Re: **Tronox LLC (TRX) Facility**  
**Nevada Environmental Response Trust (Trust) Property**  
**NDEP Facility ID #H-000539**  
Nevada Division of Environmental Protection (NDEP) Response to:  
*Soil Gas Investigation Work Plan for Parcels C, D, F, G, and H, Nevada Environmental*  
*Response Trust Site, Henderson, Nevada*  
Dated: October 2012

## Attachment A

Figure  
**2**

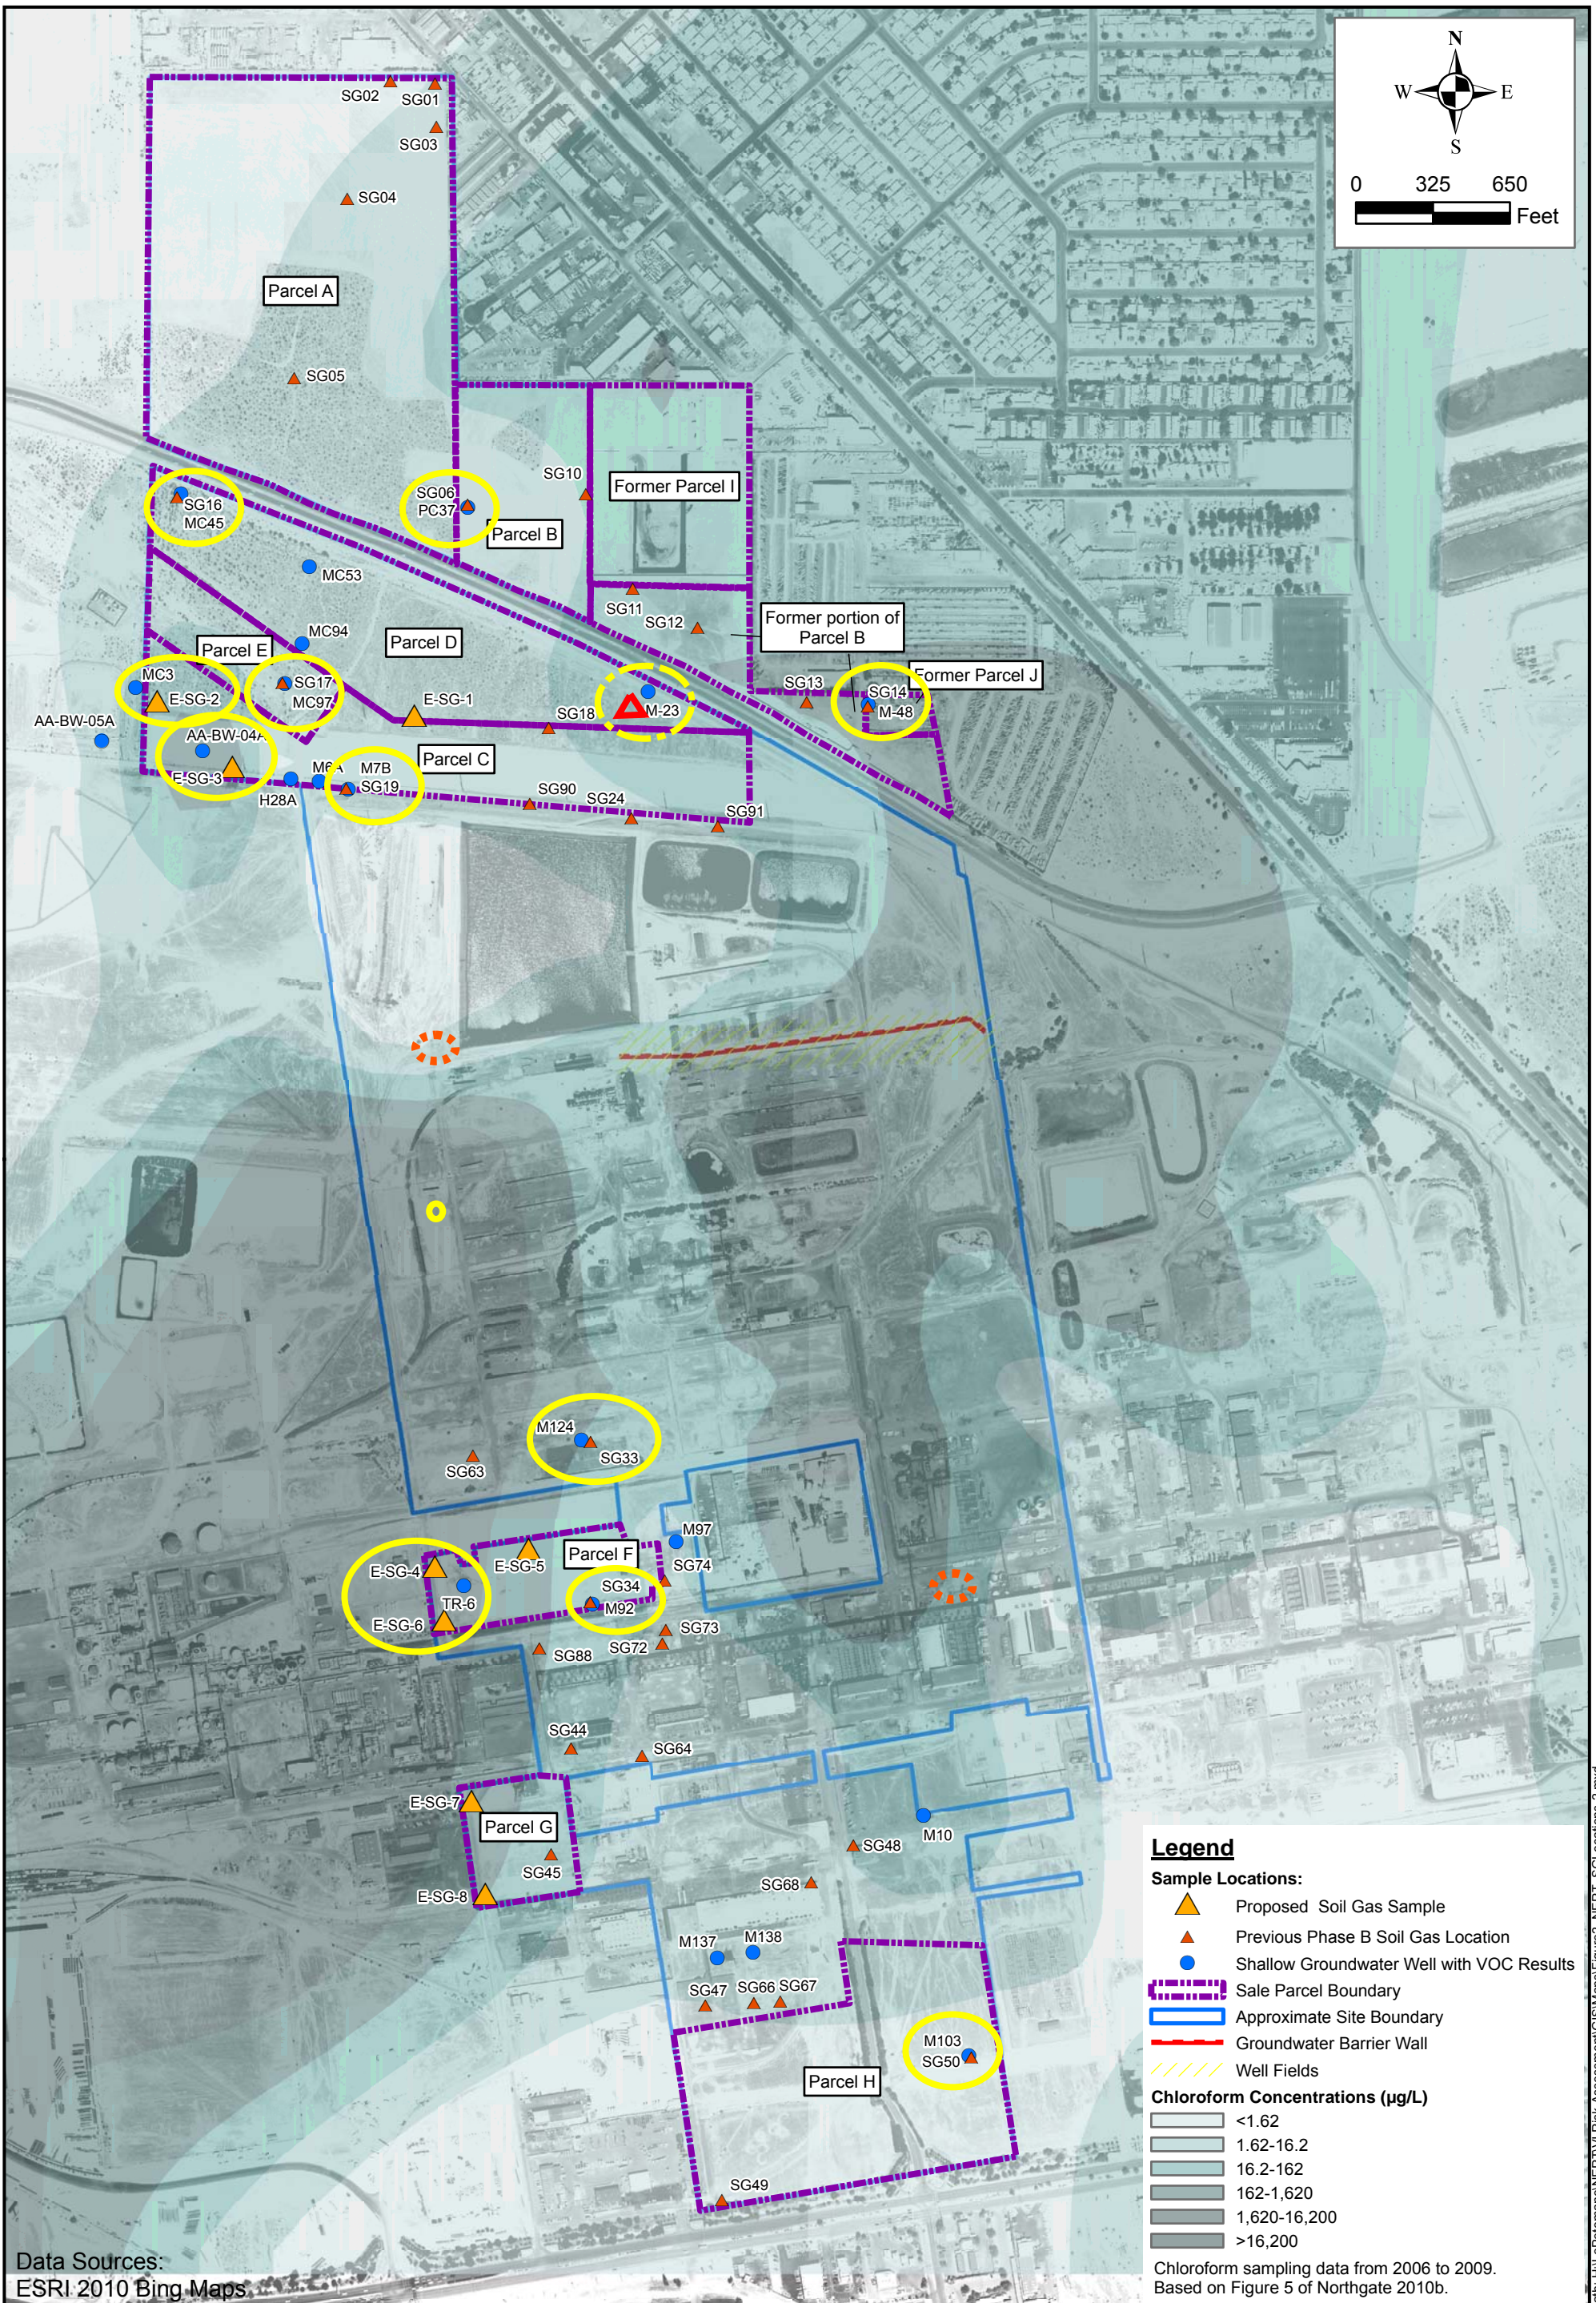
2. Section 1.4 Geologic and Hydrogeological Setting, penultimate paragraph and Figure 2, please identify the referenced paleochannels on Figure 2.
3. Section 2.0 Soil Gas Sampling and Analysis, page 7; Section 2.3 Sample Locations, page 8, first paragraph; Table 1 Proposed and Existing Soil Gas Sampling Locations; and Sections 2.3.1-2.3.5, pages 8-9; the Work Plan implies that the soil gas probes installed by ENSR in 2008 will be used in the health risk assessment (HRA). Given that these data are nearly five years old, NERT should consider comparing the new data to the 2008 data to ensure comparability. If a significant difference is observed, then the difference should be discussed as part of the Uncertainty Section in the resulting HRA.

4. Section 2.3 Sampling Locations, the Work Plan includes eight new soil gas samples. NDEP recommends one additional soil gas sample located adjacent to monitor well M-23 located in Parcel D (see attached marked up version of Figure 2). Figure 2 from the work plan shows that with the addition of one soil gas sample in Parcel D, there will be 12 locations that have collocated soil gas at five feet below ground surface (bgs) and shallow groundwater samples. Data from these collocated samples will allow further evaluation of the conclusion reached in the Site-Wide Soil Gas Human Health Risk Assessment, Section 6.1.1.1 (Northgate, 2010). Figure 2 with highlights and markups from the subject Deliverable is attached for reference to the comments herein.

5. Section 2.3 Sample Locations, page 8, last paragraph, please provide the locations of the soil property samples on Figure 2. In addition, please provide a table listing the soil types/classifications and associated properties and justification for the values to be used for the proposed samples.

12. Figure 2 Soil Gas and Groundwater Sampling Locations, NERT should also review the available well locations from the Olin site to the west as it appears that a number of wells exist that are not displayed on this figure. Sampling data from the group of Companies at the Olin site would provide a much more robust data set. However, please note that justification for using "near-parcel" sample locations for "on-parcel" risk.

13. Figure 2, NERT should confirm that there are no groundwater monitor wells in or near Parcel G (please refer to annotated version of Figure 2 attached).

14. Figure 2, NDEP provides the following comment for NERT to consider when analyzing the data: The Site-Wide Soil Gas Human Health Risk Assessment (Northgate, 2010) indicates that 25 of the soil gas sampling locations were collocated with monitor wells. The deliverable (Northgate, 2010) states that "These data were plotted and a linear regression model was applied, which showed that the data were reasonable linearly correlated (R<sup>2</sup> of 0.54). However, there are two pairs of samples (SG36/M11 and SG52/MW16) where the soil gas concentration is high but the shallow groundwater concentration is very low and these two

sets of data points appear to be outliers. When the data were re-analyzed without these samples, the linear correlation was significantly improved (R2 of 0.94). These data further support the conclusion that the source of chloroform in soil gas is shallow groundwater.” The attached Figure 2 has two dashed circles (orange) at the approximate locations and are areas where soil gas and groundwater monitoring well data are identified as outliers (Northgate, 2010) in that the soil gas concentrations were much higher than would have been indicated by groundwater concentrations at these locations. The latter might be interpreted as potential soil source as opposed to groundwater. The latter would require more work to establish but is not viewed as relevant to the Parcels C/D/E/F/G/H soil gas investigation and evaluation.
